APPLICATION NO.	FILING DATE	FIRST NAMED INVENTOR	ATTORNEY DOCKET NO.	CONFIRMATION NO.
09/828,358	04/09/2001	Karel van den Berg	8553/213	1711
75	90 06/05/2002			
Penrose Lucas Albright Esq. MASON, MASON & ALBRIGHT P.O. Box 2246 Arlington, VA 22202-0246			EXAMINER	
			SMITH, KIMBERLY S	
Ariington, VA	22202-0246		ART UNIT	PAPER NUMBER
			3644

DETAILED ACTION

(Modified)

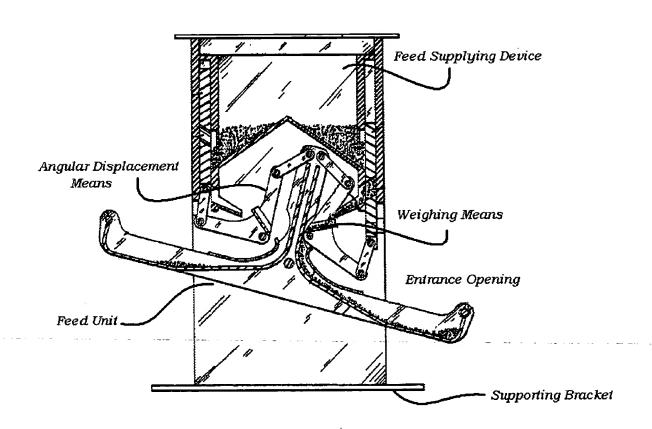
- (b) the invention was patented or described in a printed publication in this or a foreign country or in public use or on sale in this country, more than one year prior to the date of application for patent in the United States.
- 9. Claims 1, 31 and 41 are rejected under 35 U.S.C. 102(b) as being anticipated by Anderson, US Patent 5,255,631.

Anderson discloses a feed metering device for providing feed in measured portions to an animal comprising a feed unit, entrance opening, feed supplying device, weighing means wherein said feed unit is connected to the feed supplying device by an angular displacement means which comprises said weighing means, further comprising a supporting bracket for the feed unit.
